Bill No. 03R-142

FACTSHEET

TITLE: **PRELIMINARY PLAT NO. 02012, BIG THOMPSON CREEK**, requested by Ridge Development Company, to create 158 residential lots and 4 outlots, with associated waiver requests, on property generally located northeast of the intersection of South 56th Street and Yankee Hill Road.

Re: Preliminary Plat No. 02012
BIG THOMPSON CREEK

120' R.O.W. / EASEMENT SECTION

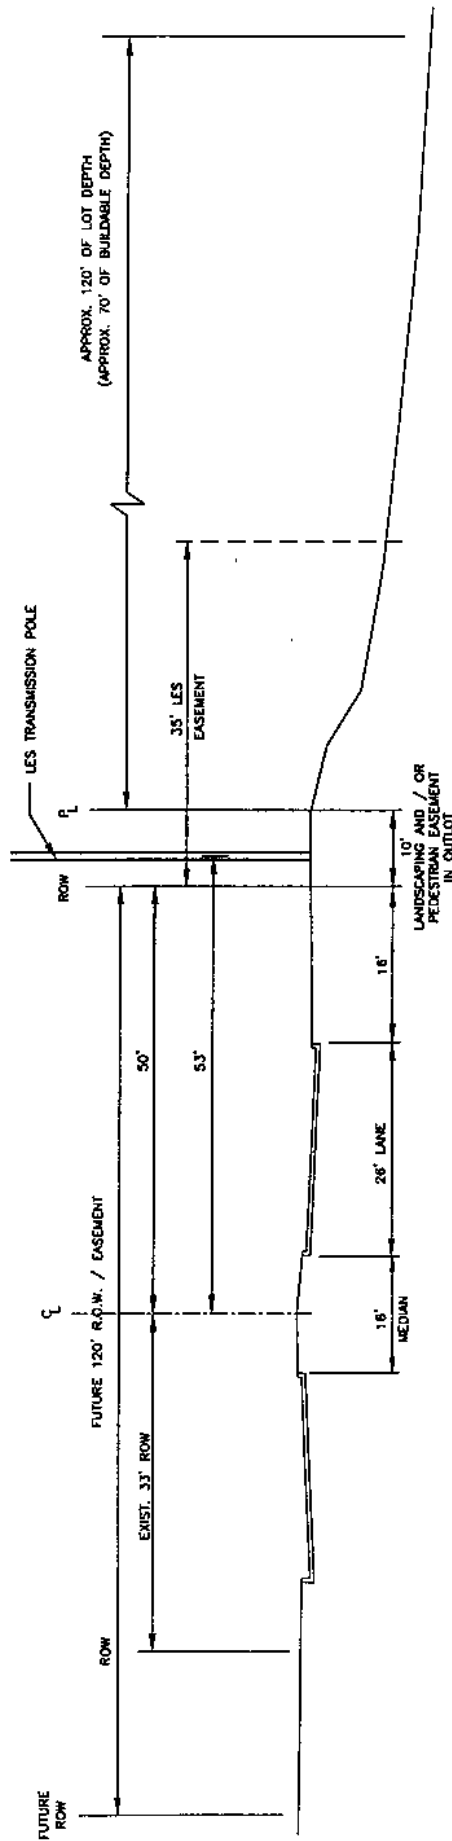
28' MEDIAN OPTION

120' R.O.W. / EASEMENT SECTION

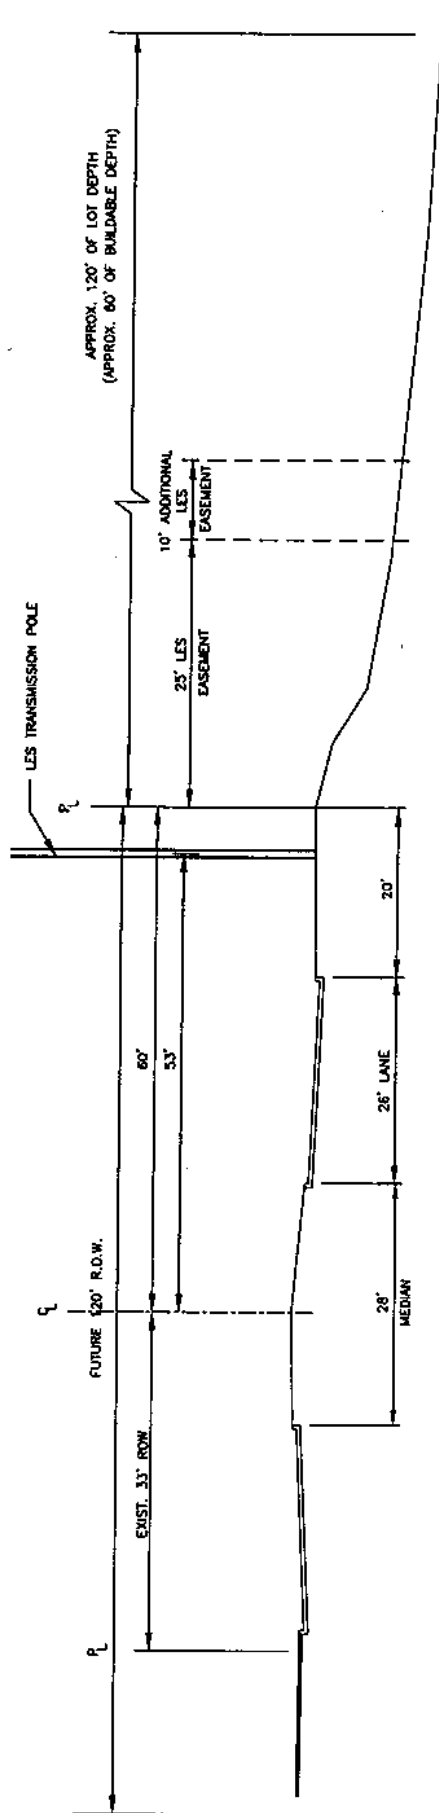
16' MEDIAN OPTION

120' R.O.W. SECTION
(PLANNING DEPARTMENTS PROPOSAL)

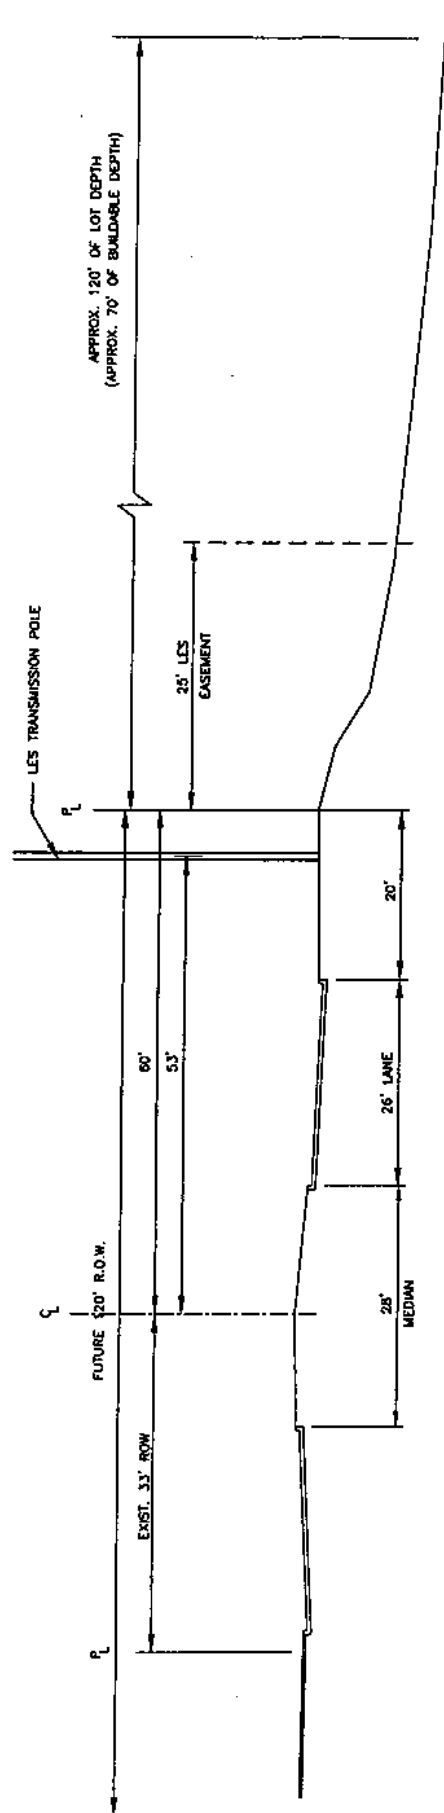
120' R.O.W. SECTION
(SUBMITTED DEVELOPER PLAN)
